SPRINGS AT WATERVIEW DRAINAGE LETTER EL PASO COUNTY, COLORADO

August 2020

PCD No. SP-16-005 PCD No. SF-16-017

Figure 5: Proposed Drainage Map

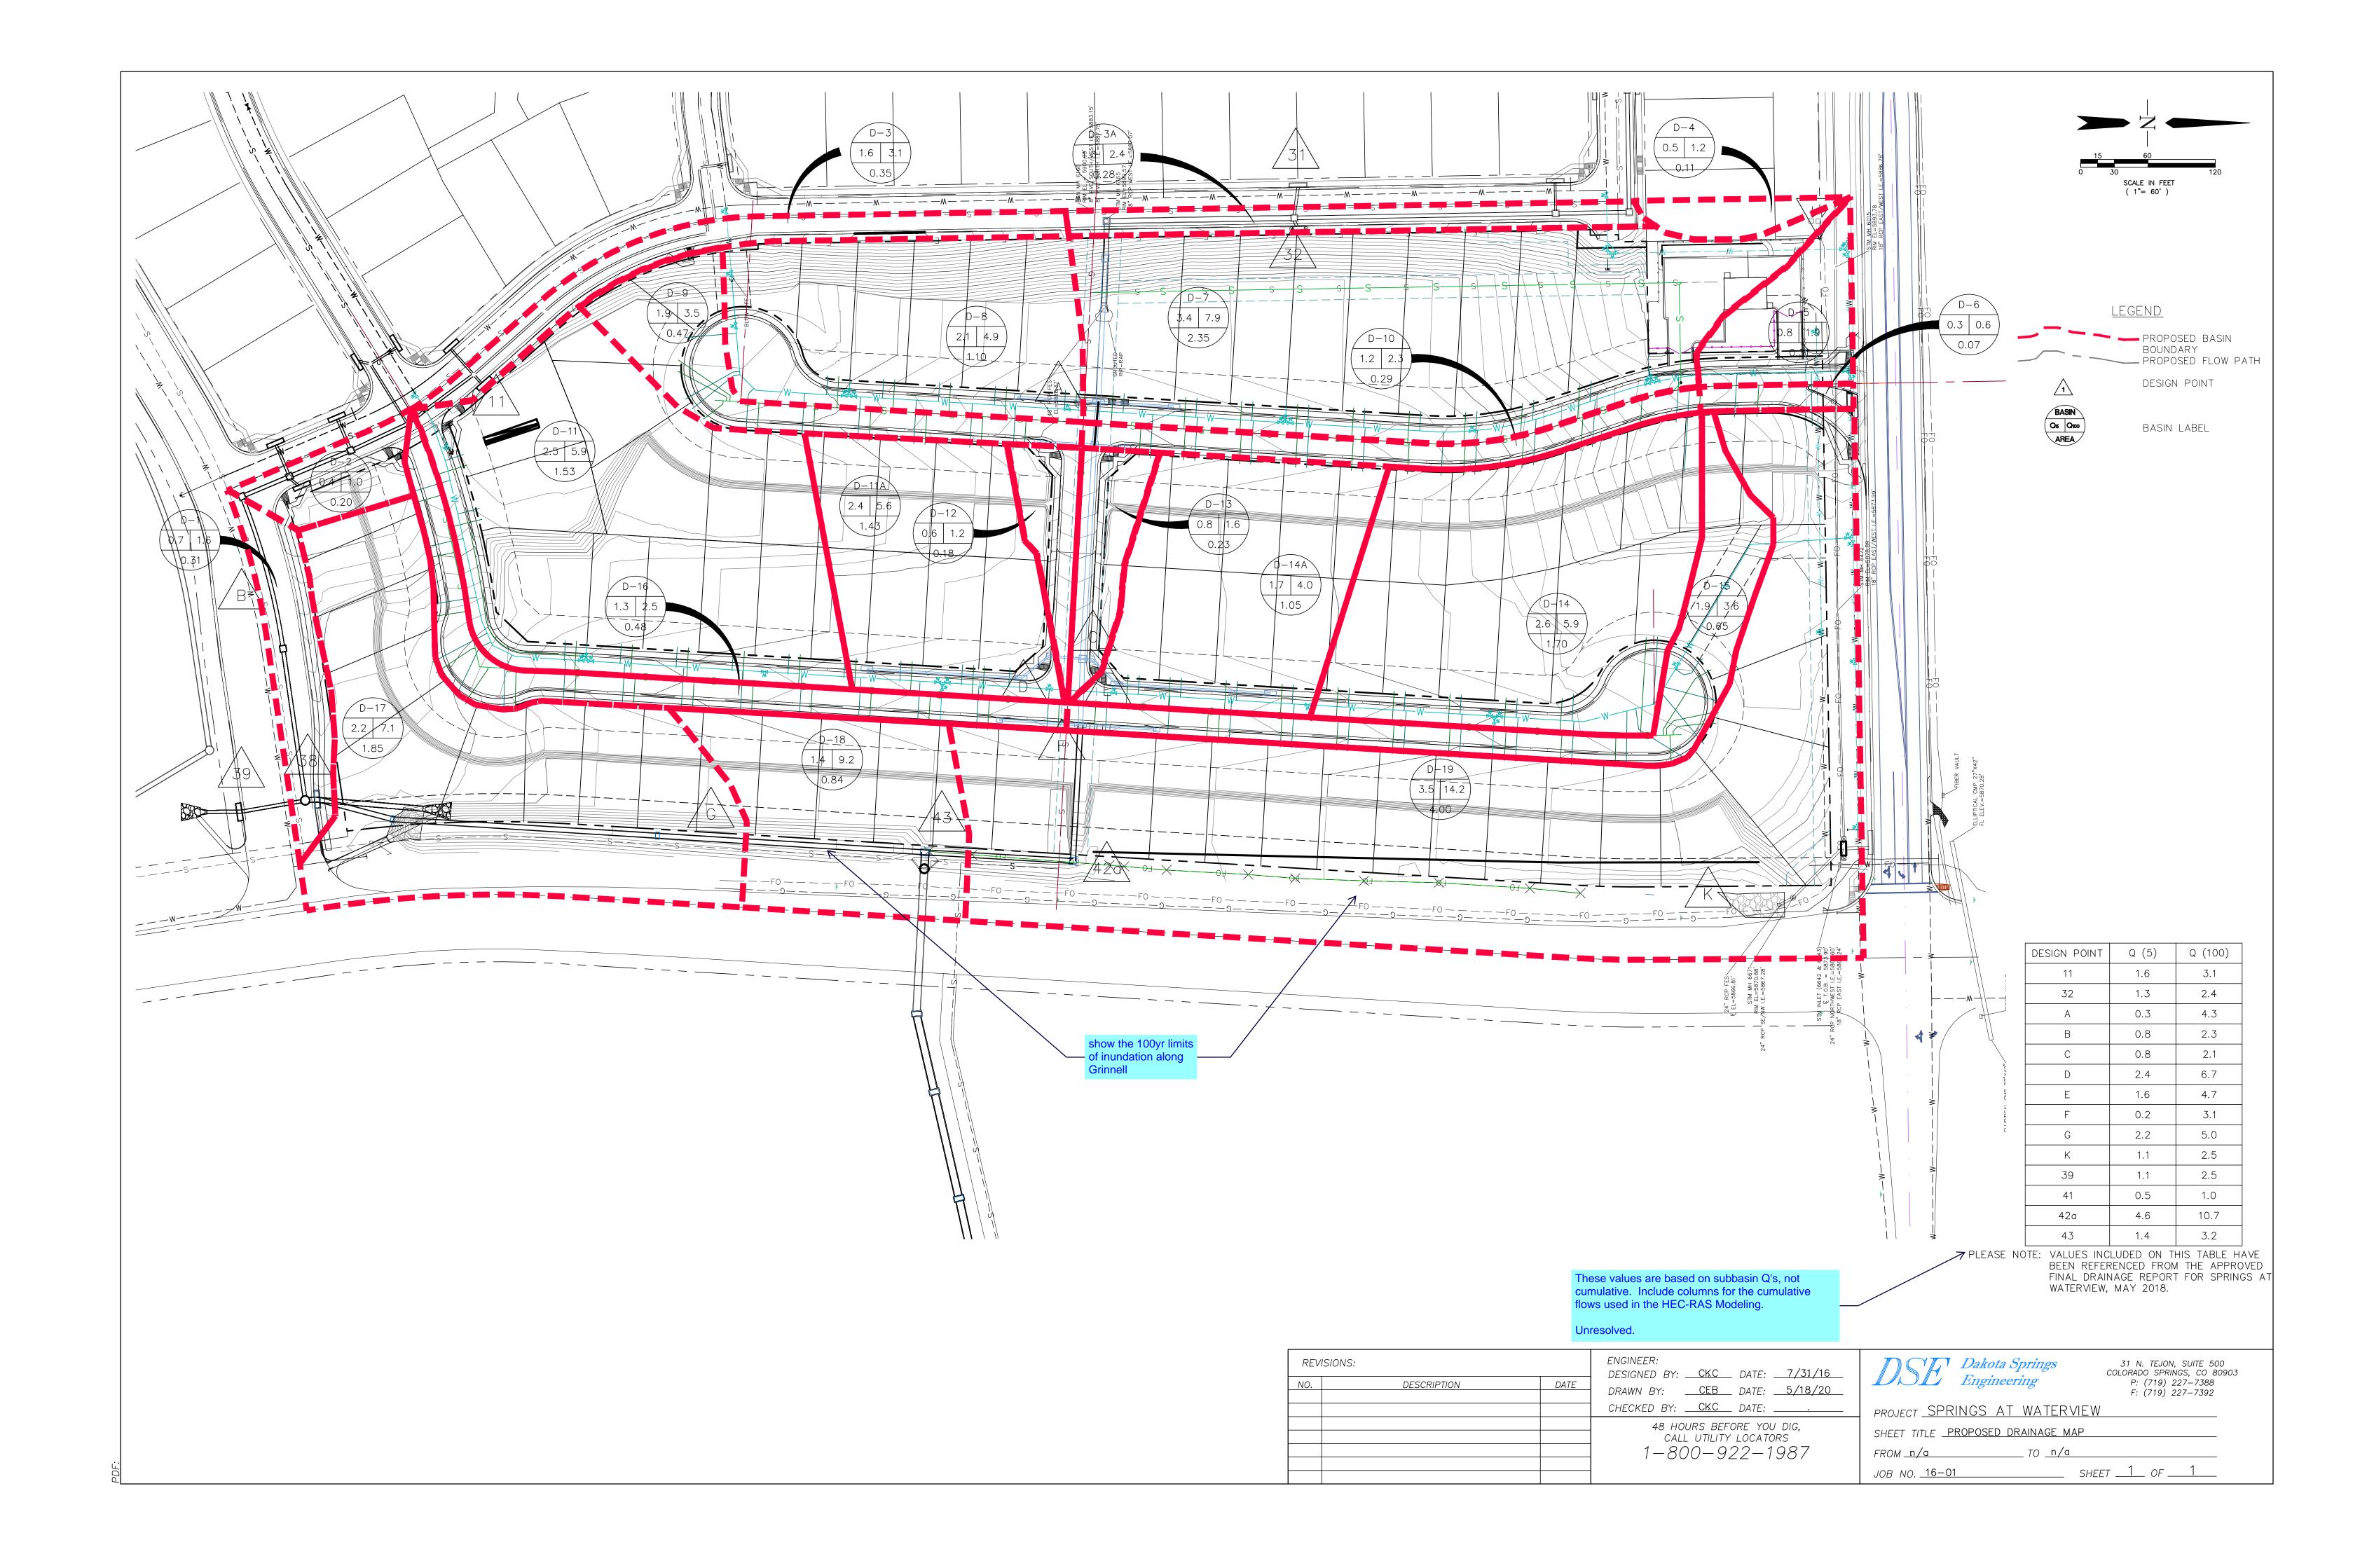
the Grinnell Boulevard roadside ditch to drain to the drainage easement and be collected in a Type D Update the grading modifications on the levard. This grading modification will help reduce the existing construction plans and the resulting levard as acknowledged and described in the approved FDR. inundation. See DCM Table 6-1 for allowable spread putations for the proposed storm sewers are contained in Appendix A of this letter.
